# **Preliminary Plat approval for Autumn Woods**

**PRELIMINARY PLAT  
A Re-Plat of Lot 1, Block 5, Neff Lakes  
'AUTUMN WOODS'**

**CASE #PP14-23**

**CASE #PDP14-23**

**PRELIMINARY PLAT**  
**A-REPLAT OF LOT 1, BLOCK 5 NEFF LAKES**  
**AUTUMN WOODS**  
 SECTION 02, TOWNSHIP 46 NORTH, RANGE 33 WEST  
 BELTON CASS COUNTY, MISSOURI  
 PARCEL NO: 05010230000004000

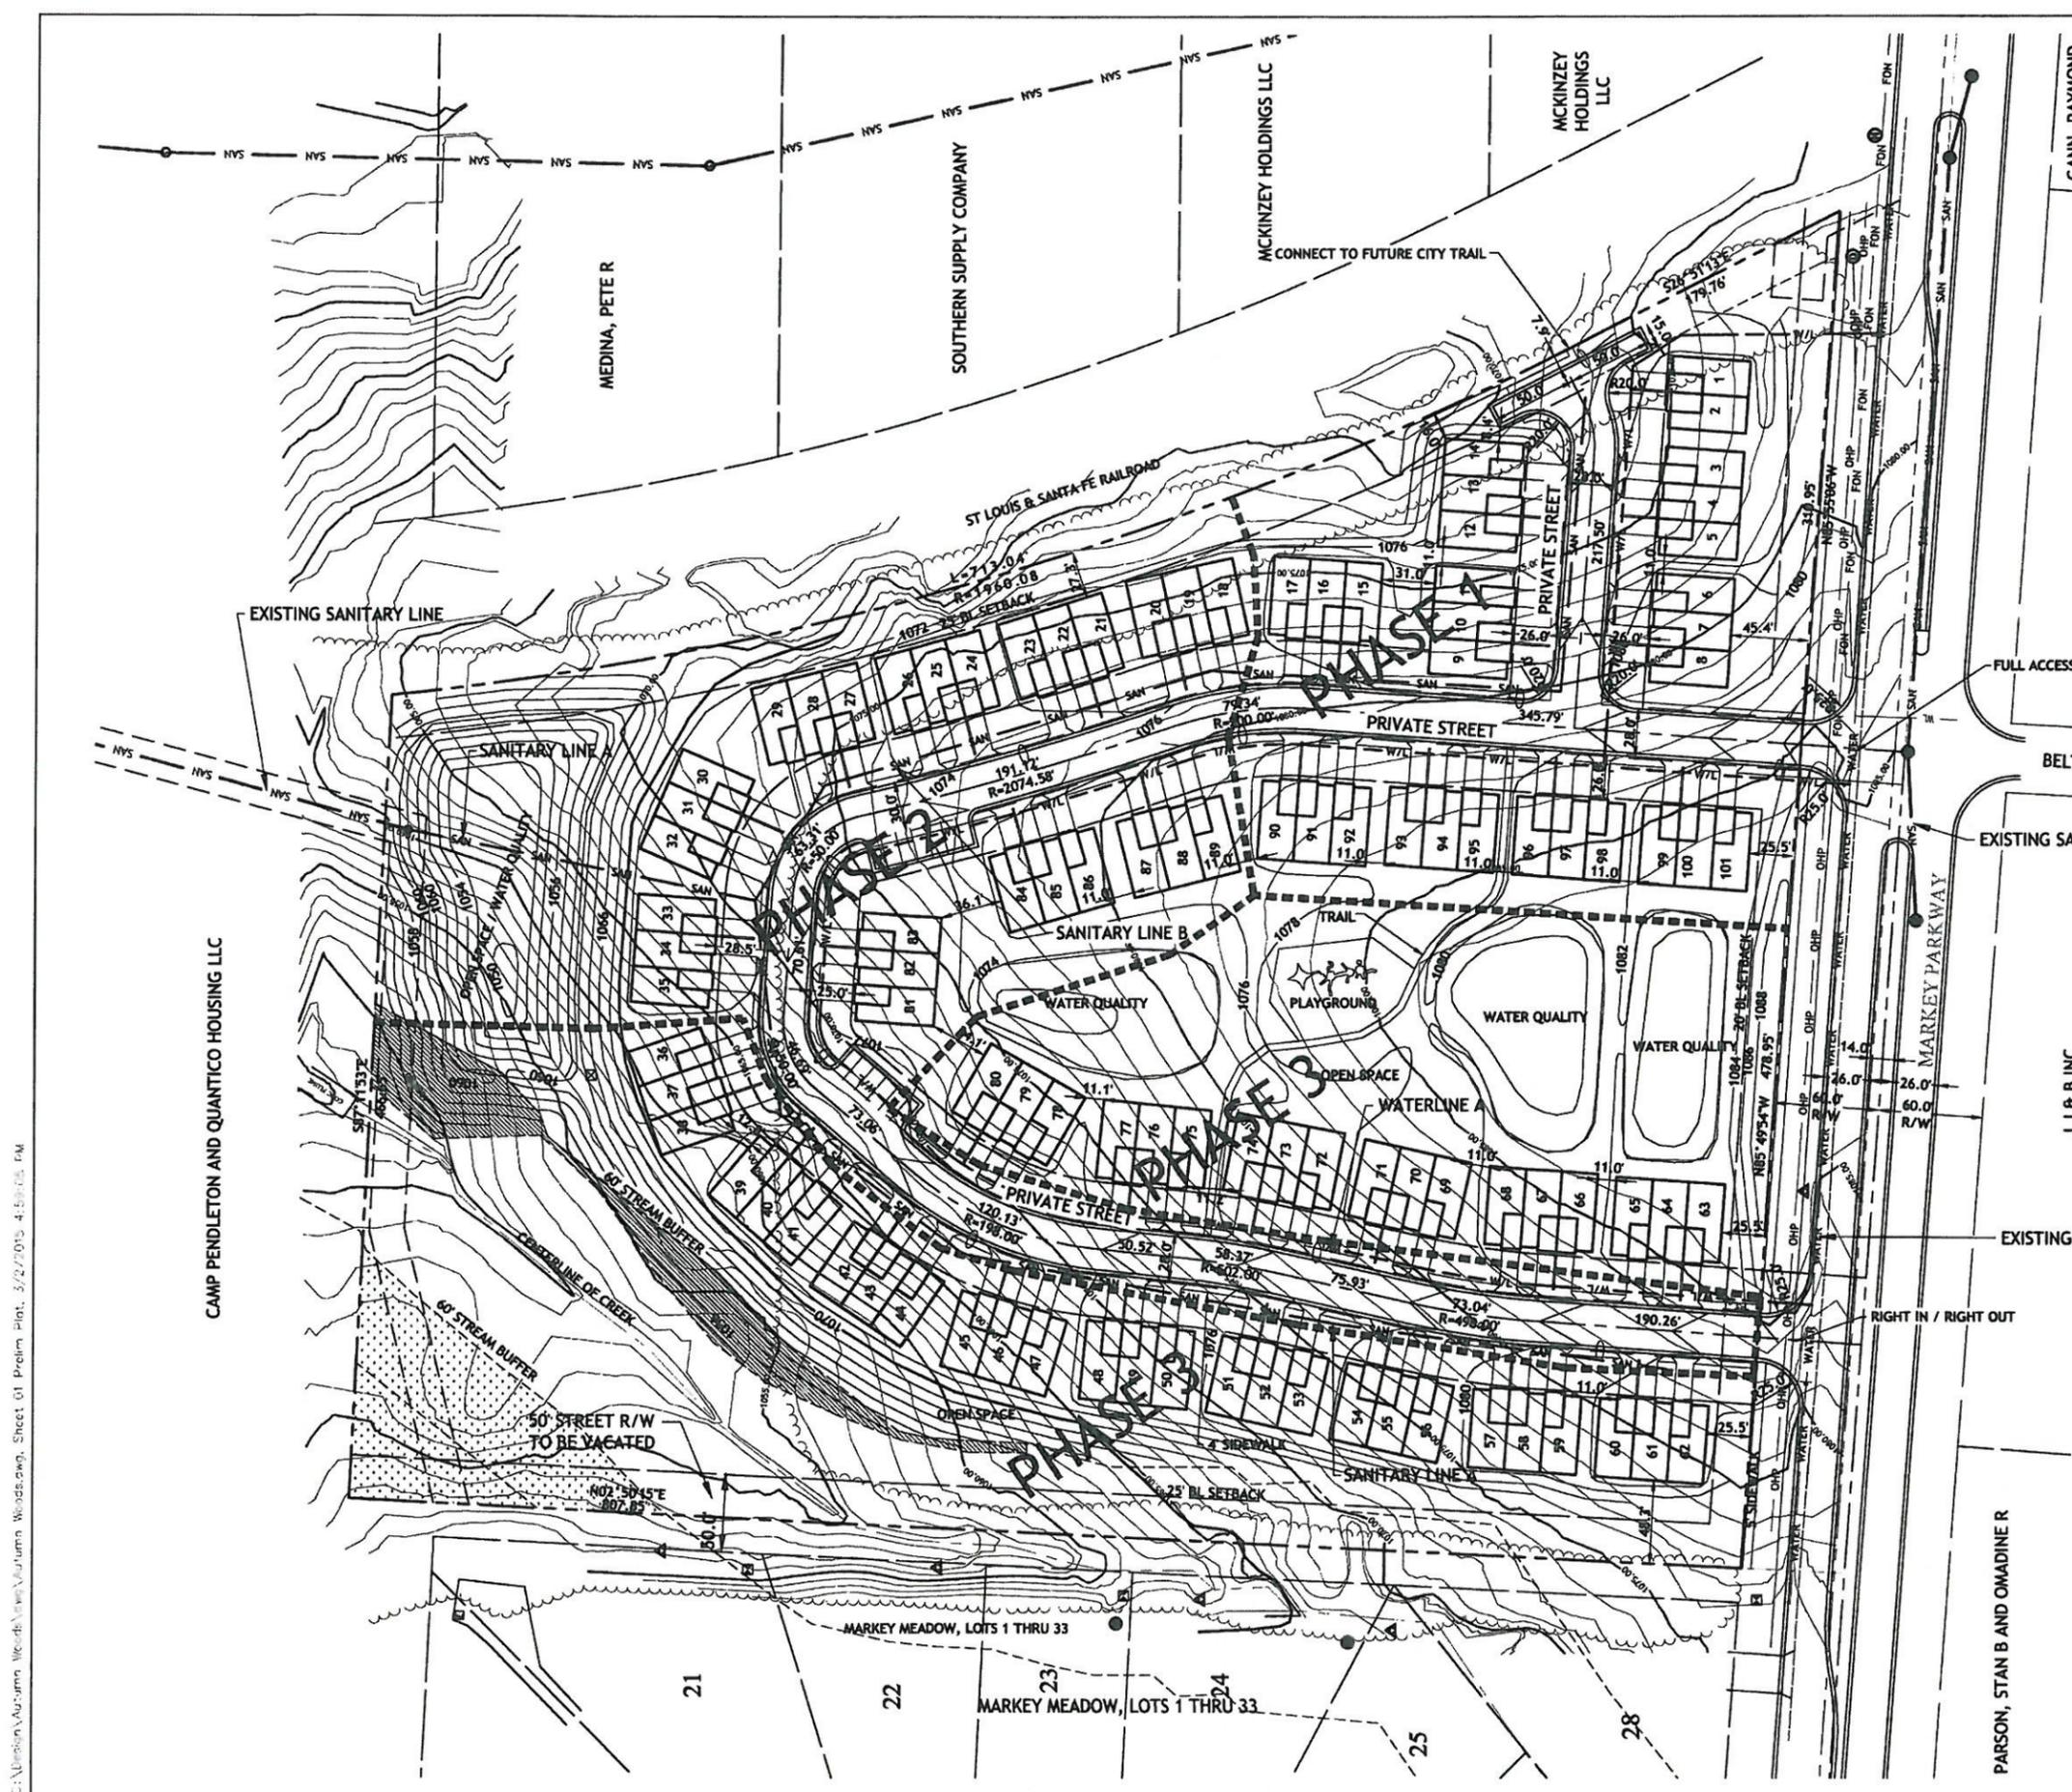
- Change Title Block to read: Preliminary Plat of Autumn Woods, a Re-plat of Lot 1, Block 5, Neff Lakes;
- Change the front yard setback to indicate a minimum of 30';
- Show all 50' of existing 'Belton Avenue' to be vacated and shown as part of the plat;

- Establish existing and proposed 100-year base flood elevations of the on-site stream and show that the project maintains one foot of protection to buildings in the adjacent development (Markey Meadows) in the 100-year event.

- Provide information on the public storm sewer system. Show 100-year on-site building protection and 100-year flow path from the water quality features near Markey Road.

- Clarify location of stream and stream buffer. See figures developed by Belton GIS.
- Provide more information on curve numbers. Which classifications from TR-55 were used to arrive at 77 and 83 for existing and proposed, respectively?

- Detention basin on north end of site must be constructed completely in conjunction with Phase 1.
- Complete and submit a City of Belton Floodplain Development Permit.

- Identify floodplain on plat and development plans.
- State of Missouri and City of Belton Greater than 1 Acre Land Disturbance Permits are required before any land disturbance activities begin. Sediment and erosion control construction plans must be reviewed and approved before issuance of the City LDP permit.

- Infrastructure to be public. Connections to public sewer to be made in compliance with the City of Belton Design and Construction Manual.
- Detailed construction plans will be reviewed by the Public Works Department upon submittal.
- Receiving public manhole has an existing rim elevation of 1061.3 feet, which is 4 feet higher than proposed grade for detention basin. Manhole will have to be lowered or grading revised.

- Plans need to list adopted codes.
- An approved turn-around will be required on any dead-ends in excess of 150'. Please refer to Appendix D of the 2012 IFC for the correct dimensions. The current dimensions on the plans don't meet code.
- I have attached a spec sheet for the turning radius of Belton's largest apparatus. Please confirm that you meet or exceed these requirements.
- Any correspondence or revisions related to the comments from the Fire Department should be submitted directly to my office to speed review.

OVERALL LAYOUT

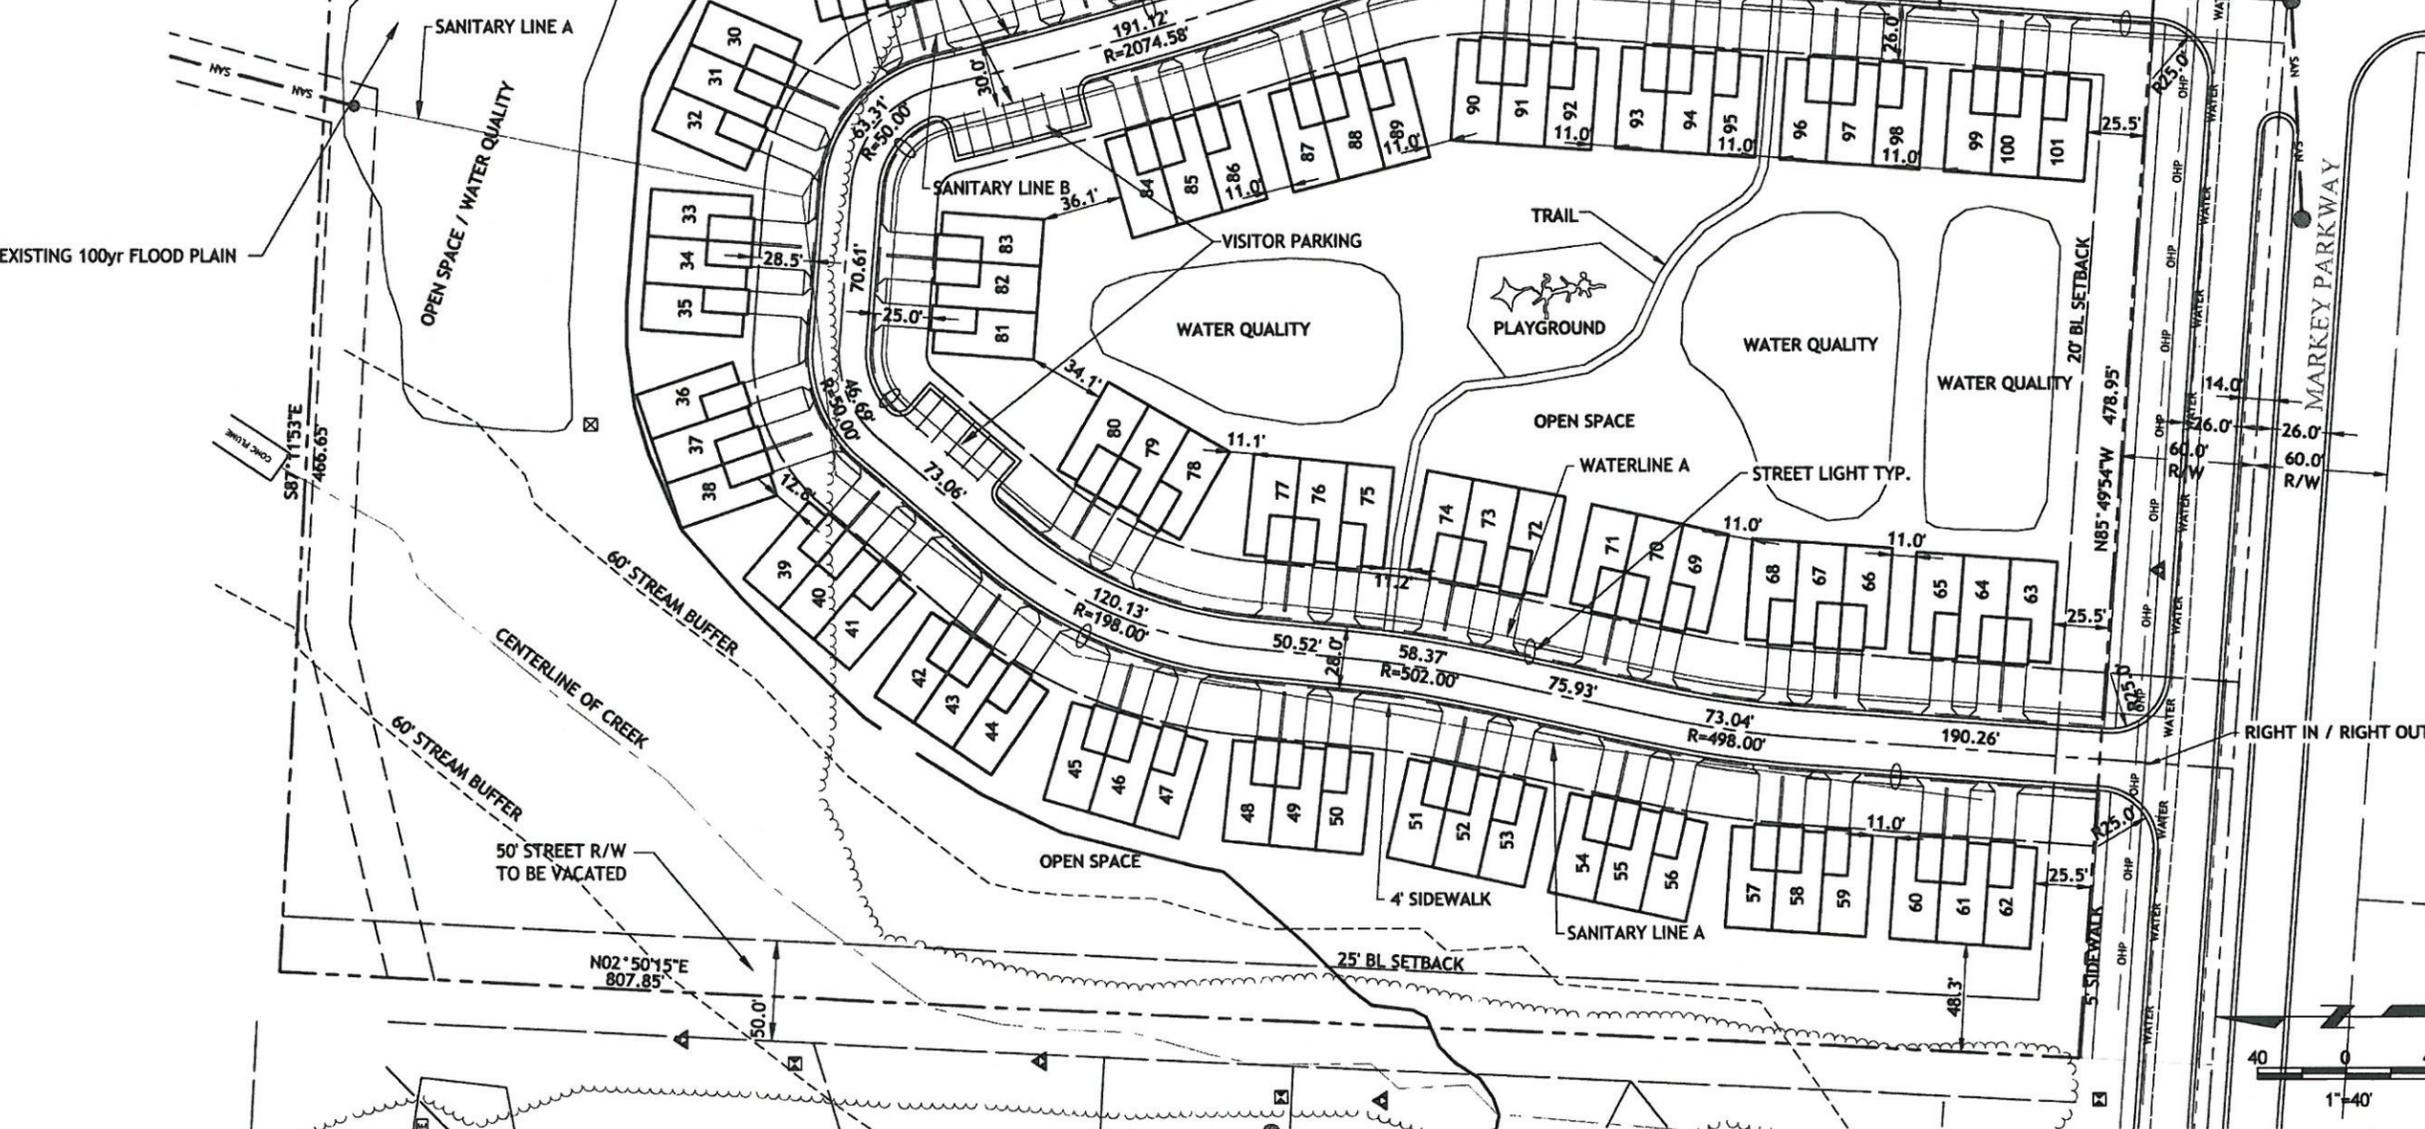
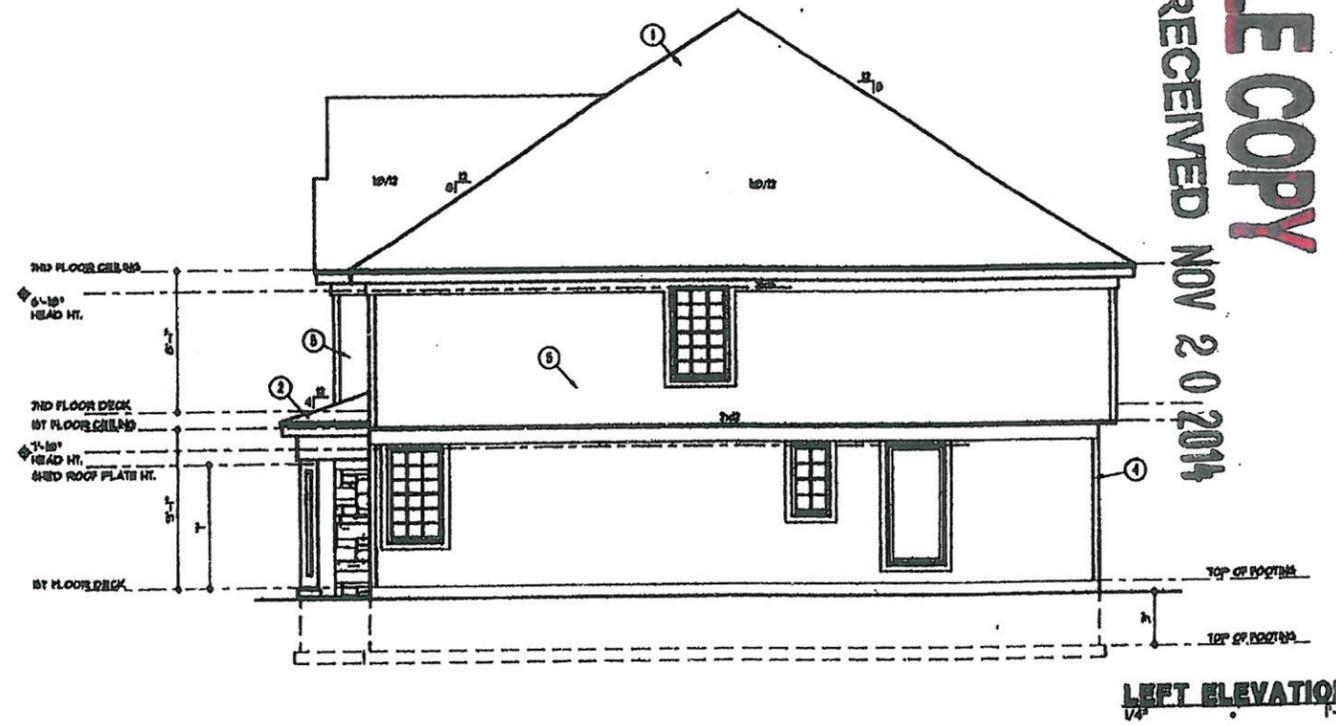
- 1. Modify the minimum driveway width from 10-ft. to 12-ft.;
- 2. Identify the location, size, and type of materials to be used in all screening of roof-top and ground mounted mechanical equipment;
- 3. Sidewalks must be installed on both sides of the street;

6. Provide an on-site visitor parking area;
7. Landscape and screening plans shall include the following:
  - Size, species, location and number of all proposed landscape materials;

- Establish existing and proposed 100-year base flood elevations of the on-site stream and show that the project maintains one foot of protection to buildings in the adjacent development (Markey Meadows) in the 100-year event.

- Provide information on the public storm sewer system. Show 100-year on-site building protection and 100-year flow path from the water quality features near Markey Road.

- Detention basin on north end of site must be constructed completely in conjunction with Phase 1.
- Complete and submit a City of Belton Floodplain Development Permit.

- Infrastructure to be public. Connections to public sewer to be made in compliance with the City of Belton Design and Construction Manual.
- Detailed construction plans will be reviewed by the Public Works Department upon submittal.
- Receiving public manhole has an existing rim elevation of 1061.3 feet, which is 4 feet higher than proposed grade for detention basin. Manhole will have to be lowered or grading revised.

7. Dead-end FD access roads in excess of 150' shall be provided with width and turnaround provisions in accordance with Table D103.4 of the 2012 IFC;
8. Gates across fire department access roads shall meet Belton Fire Department specifications and be in accordance with local fire codes;
